THOMAS GERLACH and DIRK DRÖGE
U.S. Patent Application S.N. 10/717,543

IN THE DRAWING:

Please amend FIG. 2 as follows:

Fig. 2

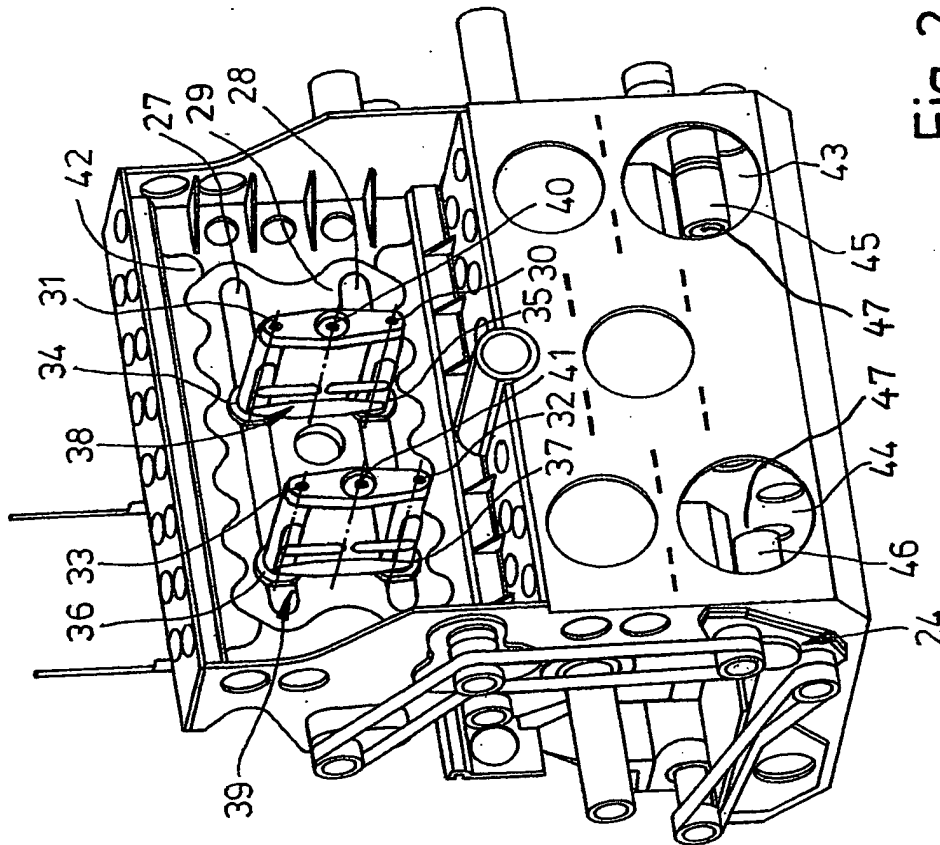
1. Please add a reference line and reference number 47 to illustrate the position sensor on drive motor 45 as indicated in red in the attached "ANNOTATED MARKED-UP DRAWINGS" of FIG. 2.

2. Please add a reference line and reference number 47 to illustrate the position sensor on drive motor 46 as indicated in red in the attached "ANNOTATED MARKED-UP DRAWINGS" of FIG. 2.

After the telephone interviews the undersigned attorney reviewed the Specification and discovered the drawing, namely FIG. 2 did not show a position sensor even though paragraph 25 and claim 10 of the Specification as originally filed claimed and described the position sensor.

Under 37 CFR § 1.83 and MPEP § 608.02(d) the drawing must show every feature specified in the claims. The original drawings, Specification and claims show the features but the claimed position sensor is not referenced in the drawing (FIG. 2). As a result FIG. 2 should be amended as well as Paragraph 0054 of the Specification to incorporate reference lines and reference numbers 47.
